SERVICE BULLETIN

SP – 039

DATE: March 22, 2019
TO: All Service and Parts Managers
SUBJECT: GPC1436H41DD and GPG1436040M41AB Serial/Rating Label

Figure 1: GPG1436040M41AB serial/rating label

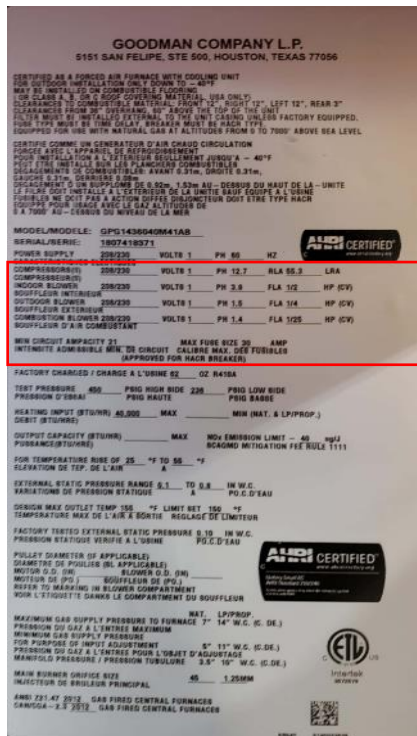
The serial/rating label for the GPC1436H41DD and the GPG1436040M41AB residential package units built between April 11th, 2018 and December 11th, 2018 (serial number prefix 1804 through 1812) have incorrect Minimum Circuit Ampacity (MCA) and Max Fuse Size (MOP). The MCA values for the GPC1436H41DD and GPG1436040M41AB units listed below fall within the same minimum wire gauge for a copper conductor.

| GPG1436040M41AB Serial Rating Label | Incorrect Value | Correct Value |
|-------------------------------------|-----------------|---------------|
| Minimum Circuit Ampacity (MCA) | 21 amp | 23 amp |
| Max. Fuse Size | 30 amp | 35 amp |

The replacement label for the GPG1436040 units (Figure 3) is a small section of the complete label (Figure 1) and contains the correct electrical data. It should be installed below the smaller AHRI Certified logo.

Figure 4: GPC1436H41DD serial/rating label

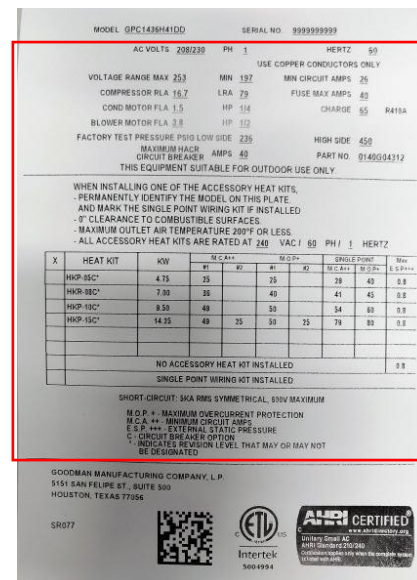
| GPC1436H41DD Serial Rating Label | Incorrect Value | Spec Sheet* | Correct Value |
|----------------------------------|-----------------|-------------|---------------|
| Minimum Circuit Ampacity (MCA) | 21 amp | 26.2 | 24.8 amp |
| Max. Fuse Size | 30 amp | 40 amp | 40 amp |

*NOTE: The MCA correct value listed in the table above for the GPC1436H41DD is a calculated value for the motors in this unit, while the MCA value in the spec sheet represents the motor manufacturers' Rated Load Amp values for the motors. The MCA on units produced prior to this error and as listed in the spec sheets and other documentation will remain different than this calculated MCA.

The replacement label for the GPC1436H41 units (Figure 5) is a portion of the complete label (Figure 4) and contains the calculated motor values and other electrical data. The replacement label should be installed just below the model and serial number of the existing label so they are not obscured.
